802.16e™

**IEEE Standard for
Local and metropolitan area networks**

**Amendment 2: Physical and Medium Access
Control Layers for Combined Fixed and Mobile
Operation in Licensed Bands**

**IEEE Std 802.16e™-2005 and
IEEE Std 802.16™-2004/Cor1-2005**
(Amendment and Corrigendum to
IEEE Std 802.16-2004)

Figure 86a – CDMA Initial Ranging – SS (part 3)

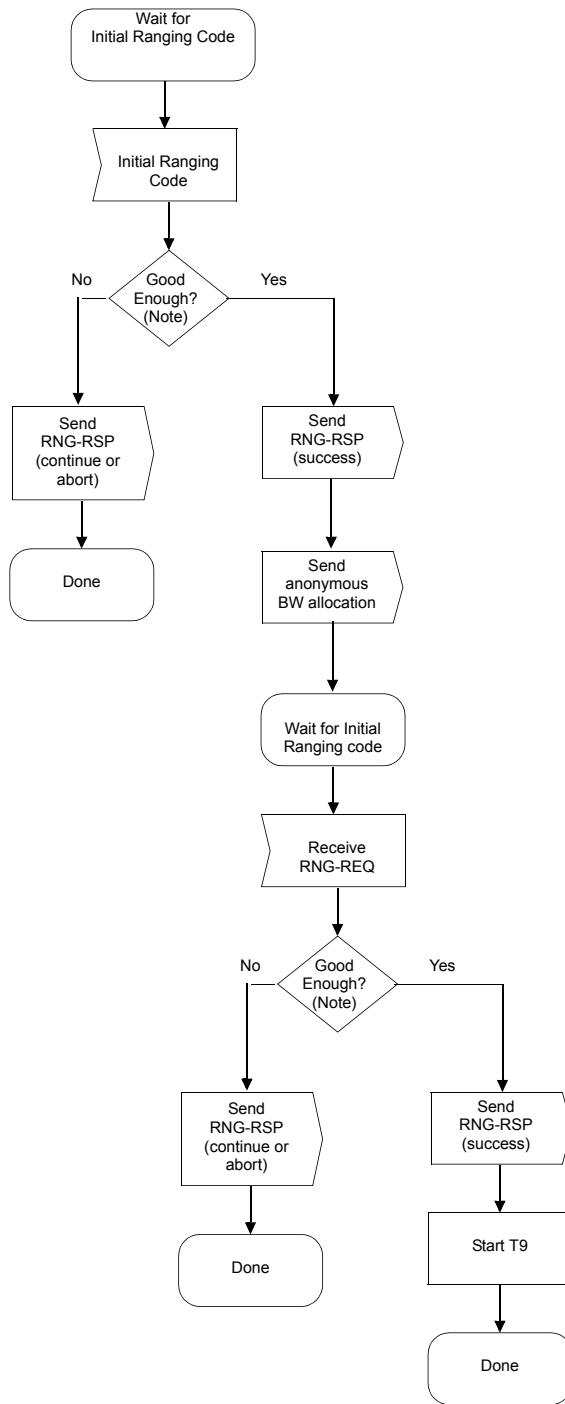
Insert the following figure:

Figure 90—Periodic CDMA ranging—SS

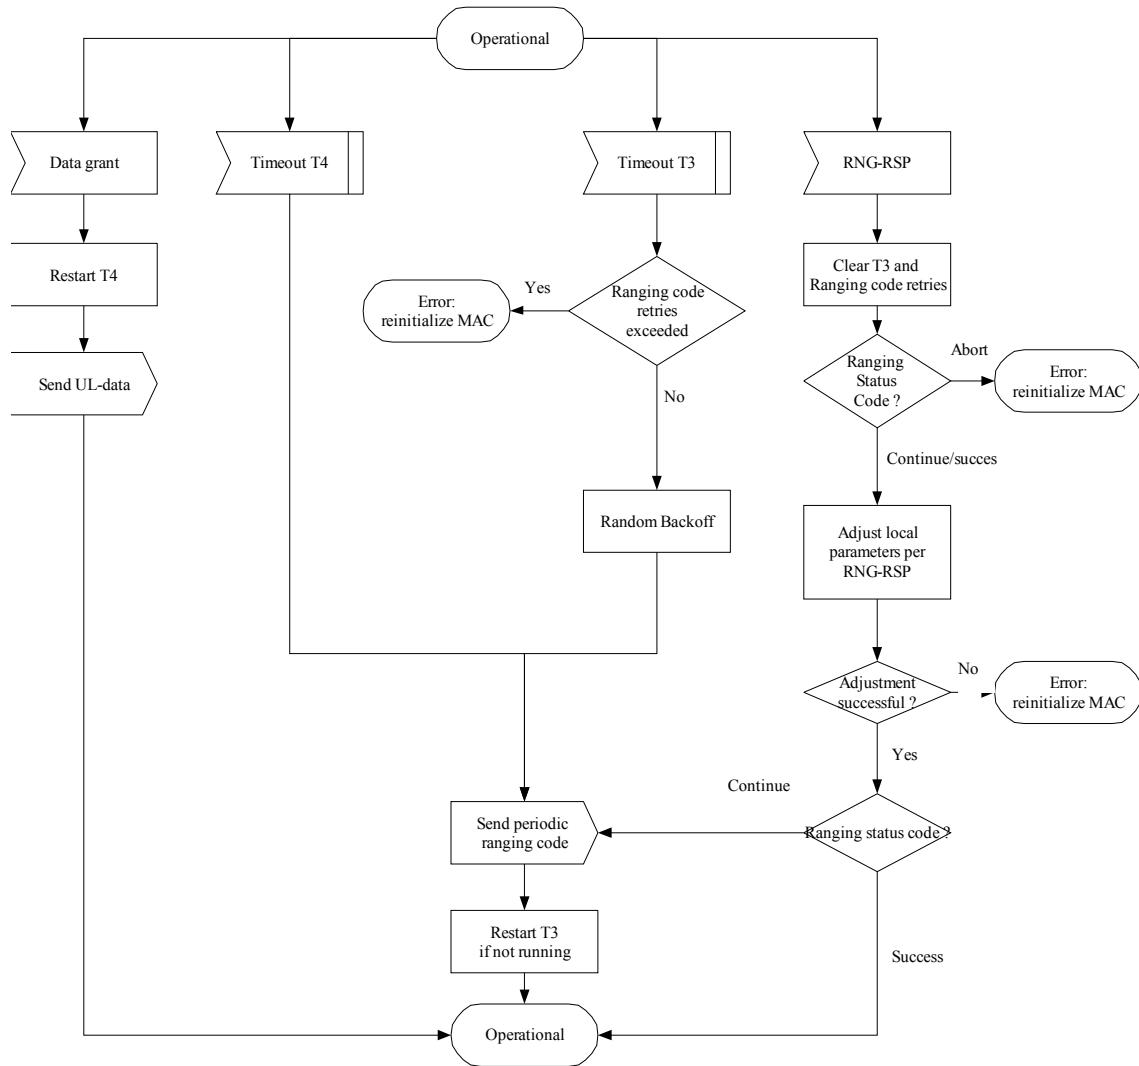
Replace Figure 90 with the following figure:

Figure 95—Theory of Operation Object Model

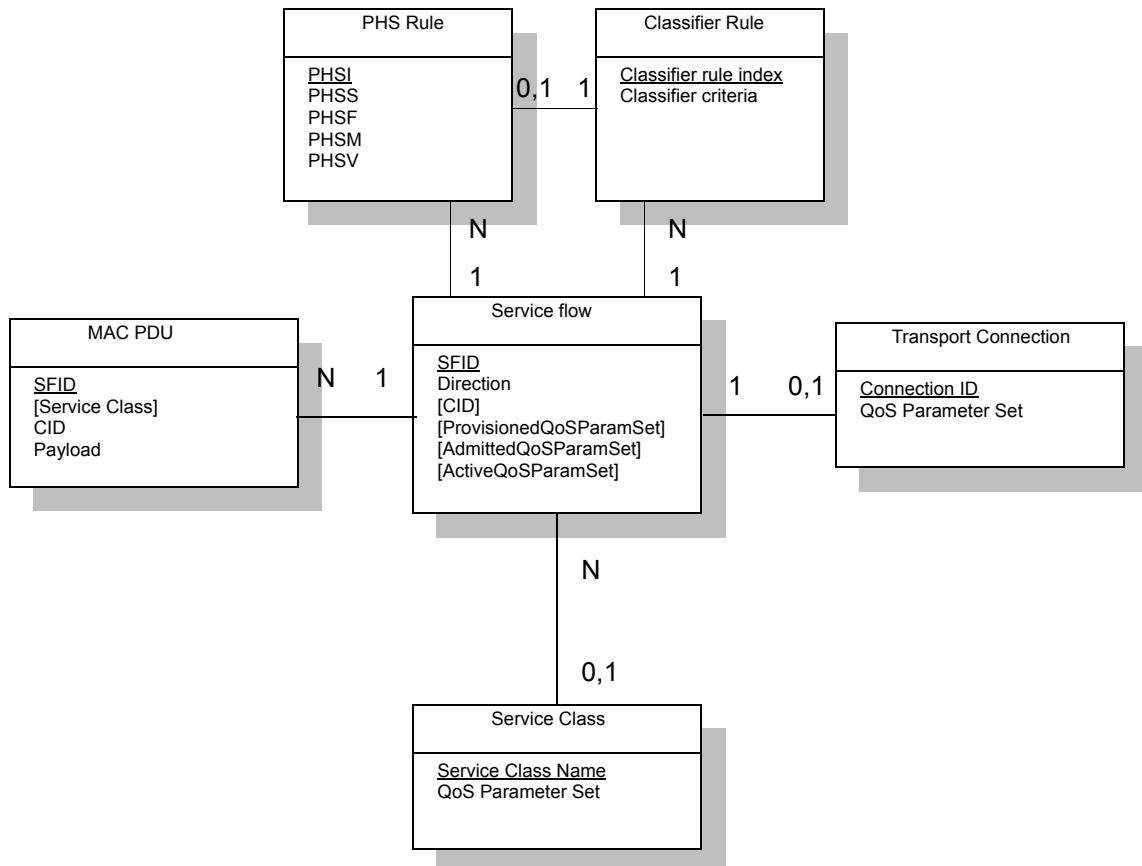
Replace Figure 95 with the following figure:

Figure 134—TEK management in BS and SS

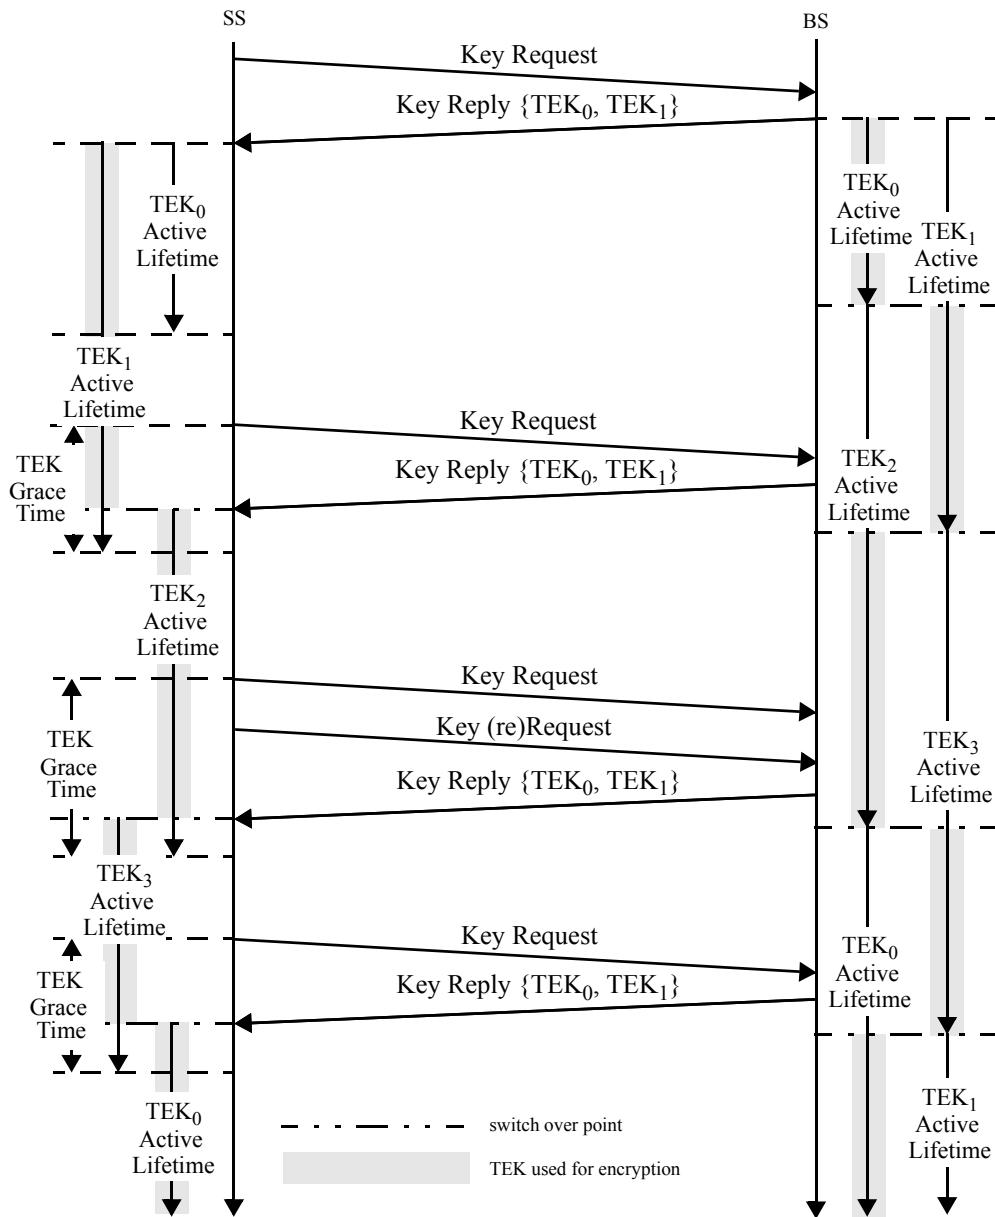
Replace Figure 134 TEK Management in BS and SS with the following figure:

Figure 207—Example of OFDM frame structure with TDD

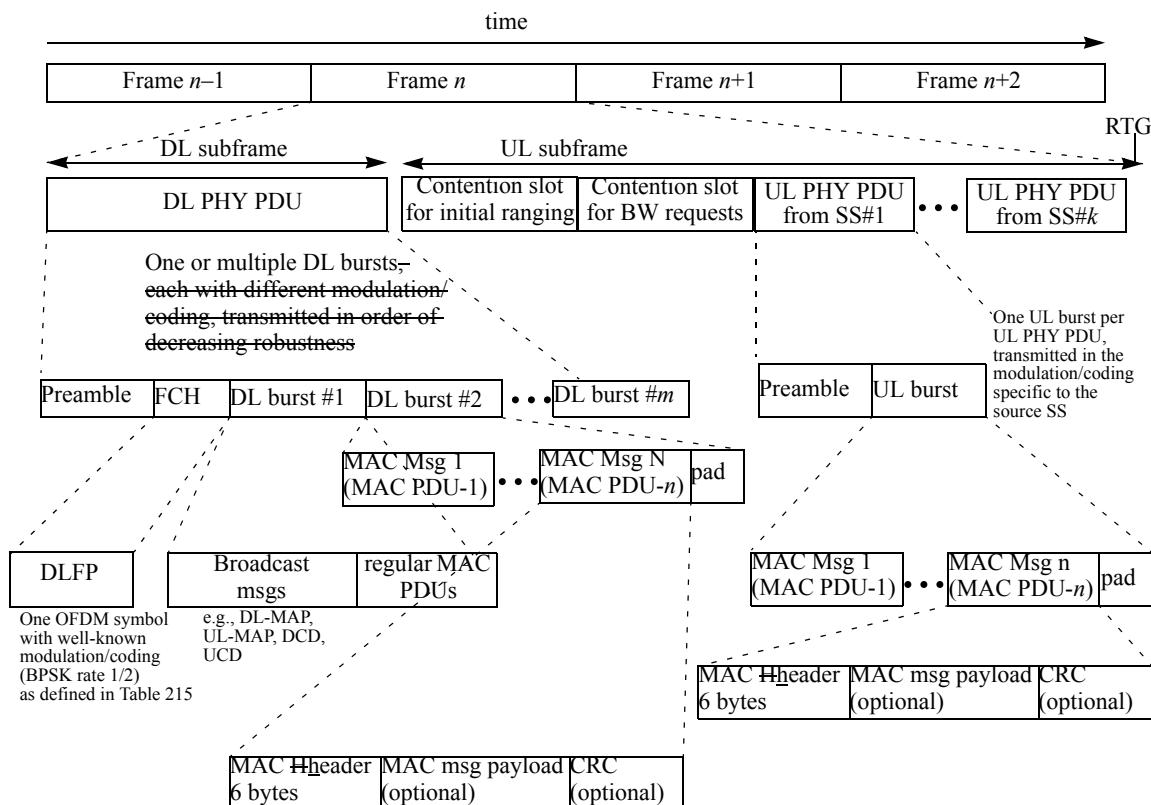
Change Figure 207 as indicated:

Figure 208—Example of OFDM frame structure with FDD

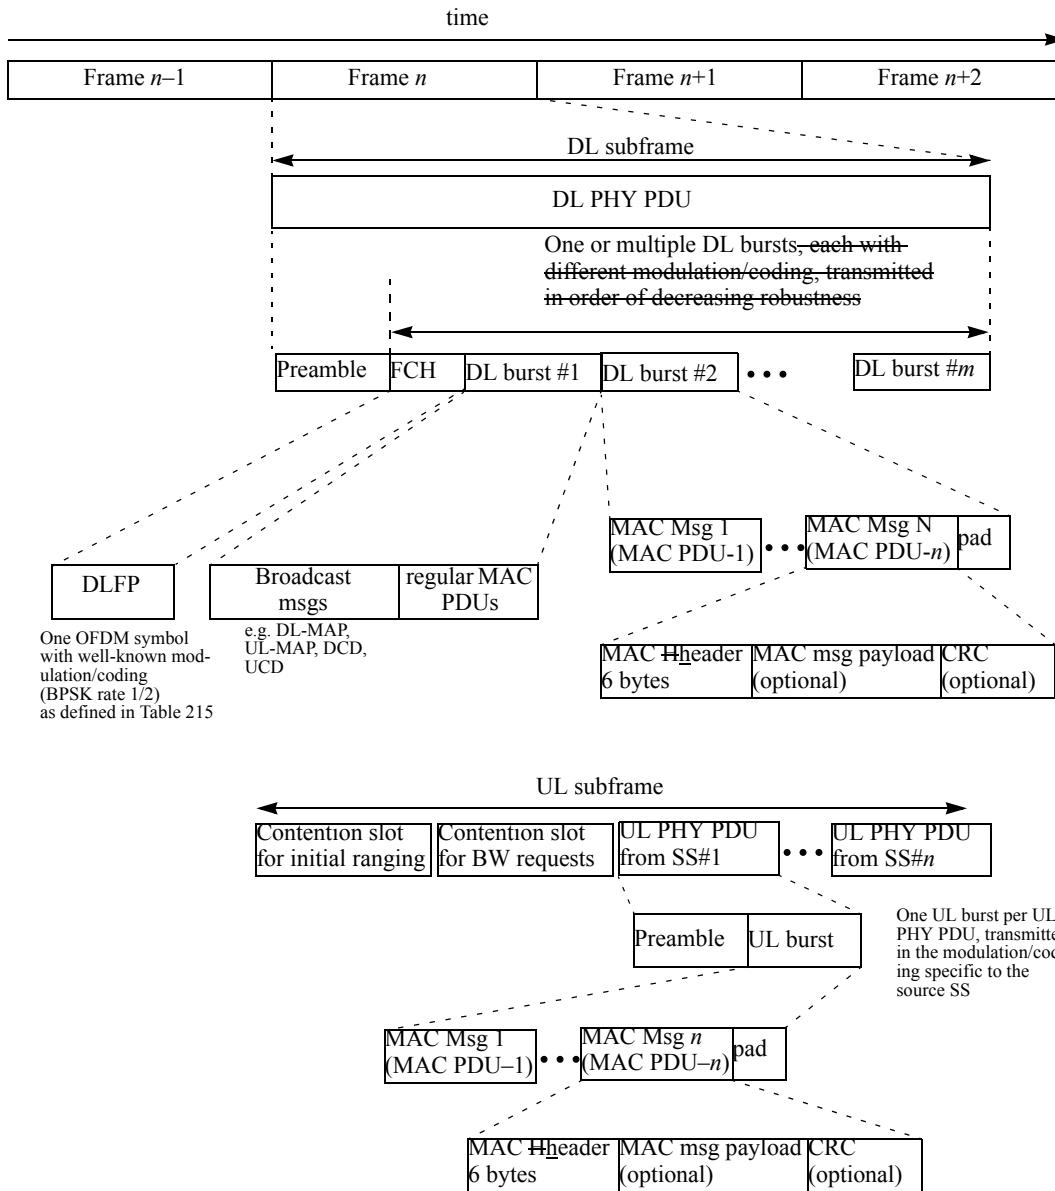
Change Figure 208 as indicated:

Figure 209—Structure of AAS Zone

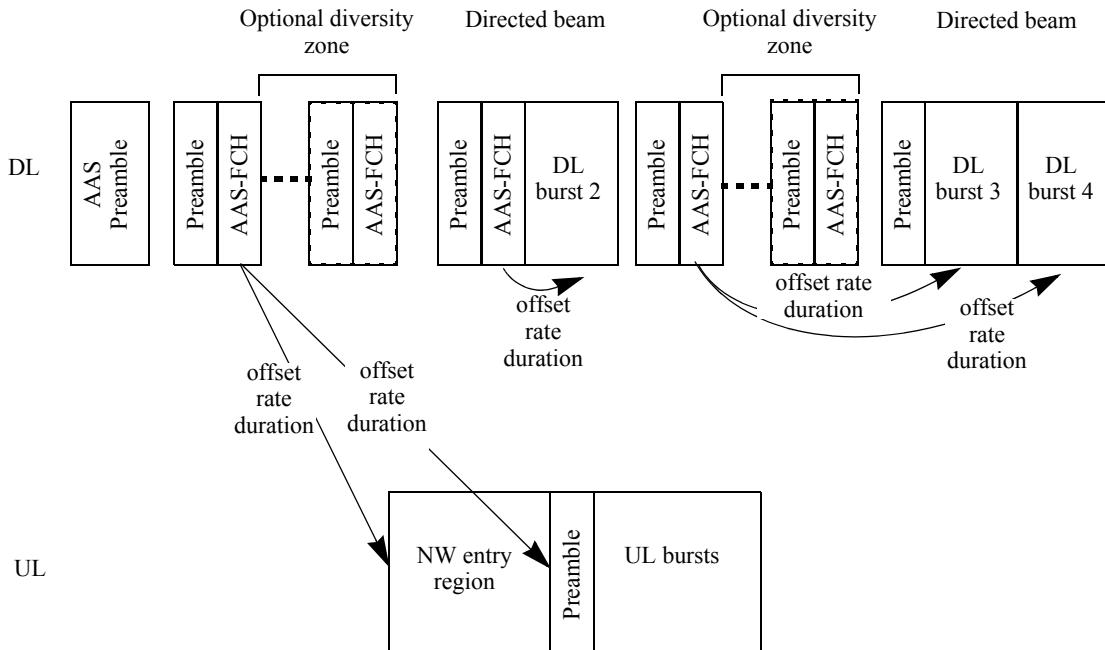
Replace Figure 209 with the following figure:

Figure 210a—Subchannelized Initial Ranging—SS (part 1a)

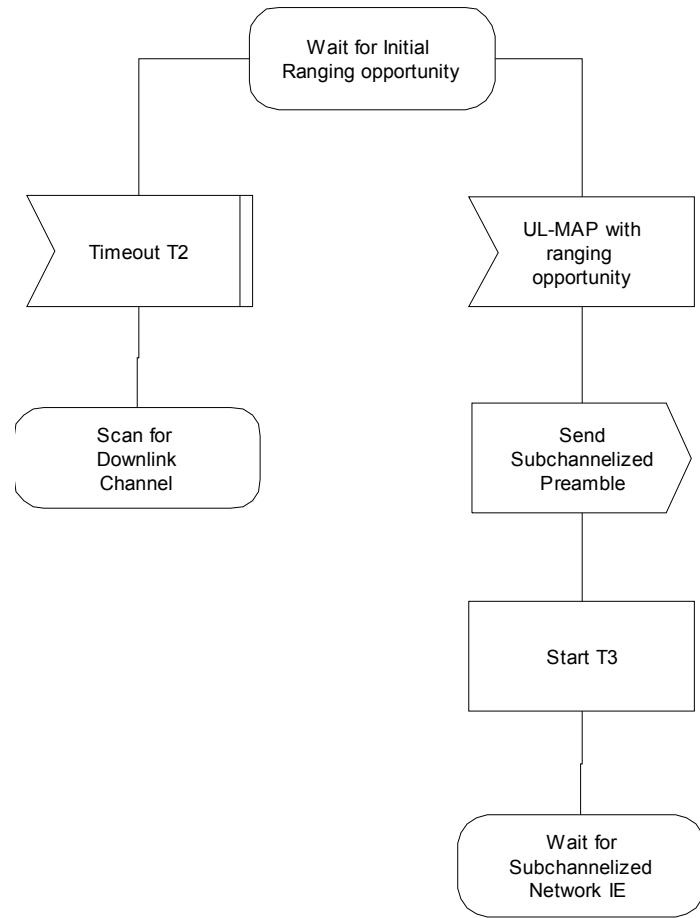
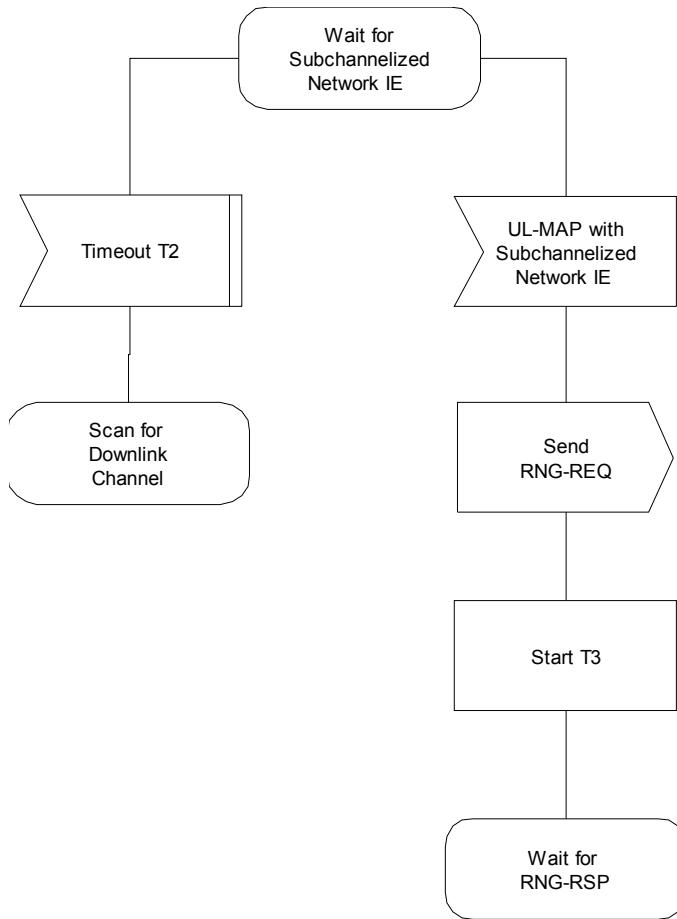
Insert the following new figures (Figure 210a and Figure 210b) into the subclause:

Figure 216—Example of mapping OFDMA slots to subchannels and symbols in the downlink (in PUSC mode)

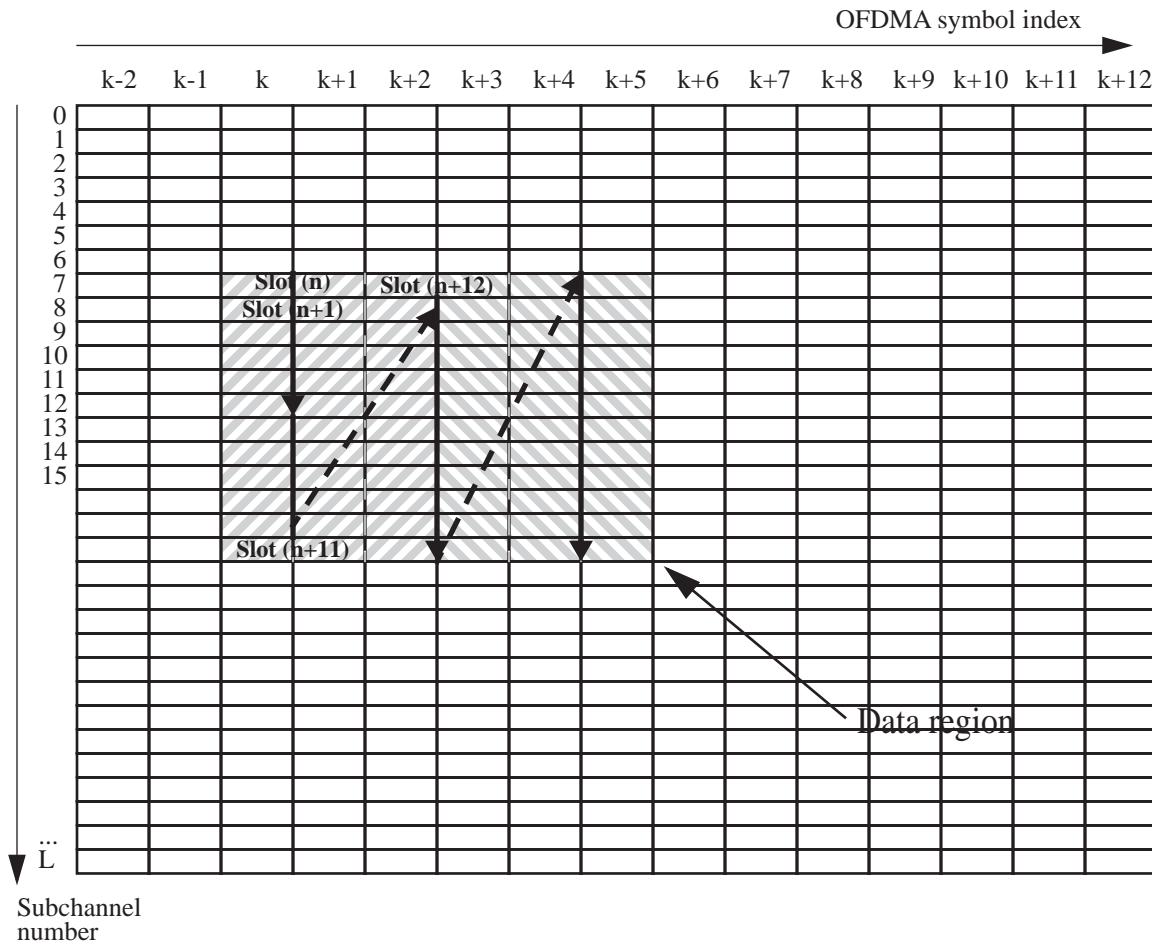
Replace Figure 216 and Figure 217 with the following figures:

Figure 218—Example of an OFDMA frame (with only mandatory zone) in TDD mode

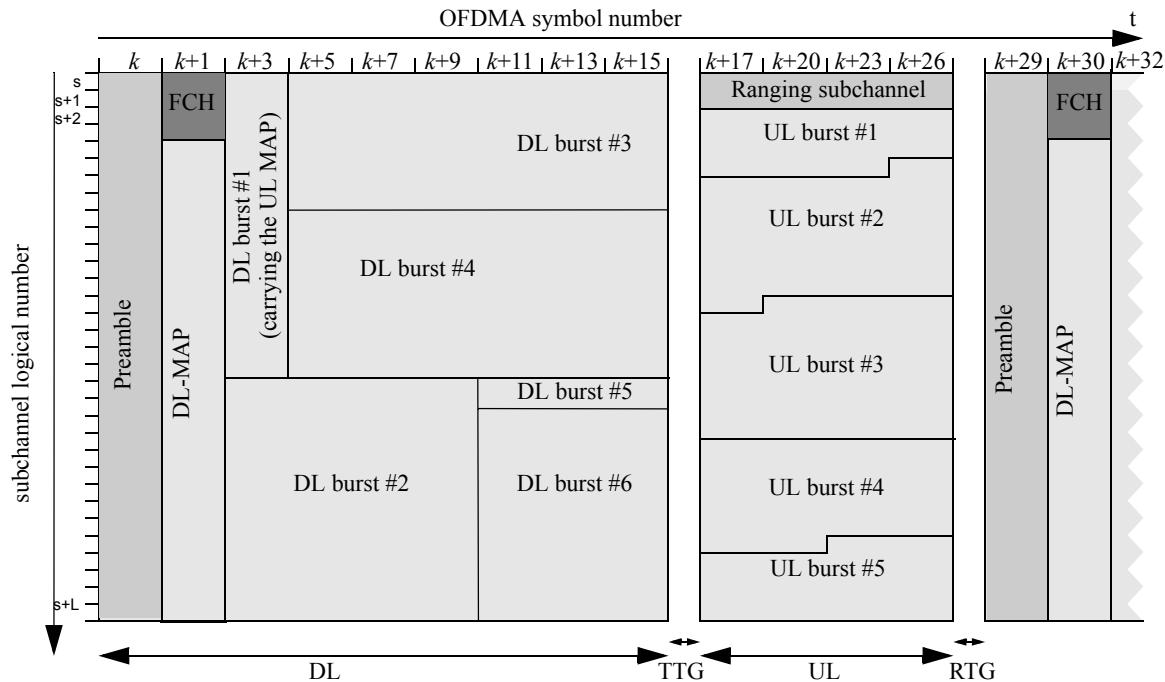
Replace Figure 218 with the following figure:

Figure 219—Illustration of OFDMA frame with multiple zones

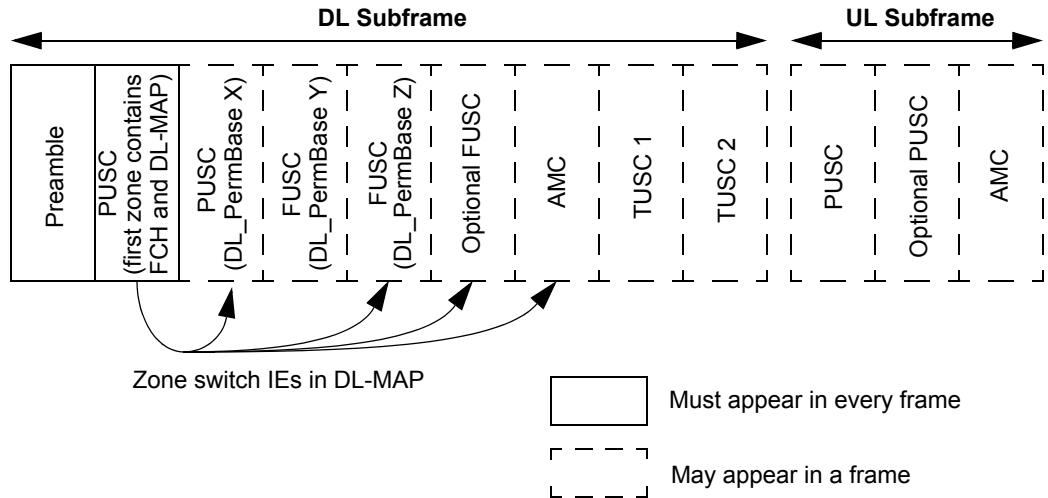
Replace Figure 219 with the following figure:
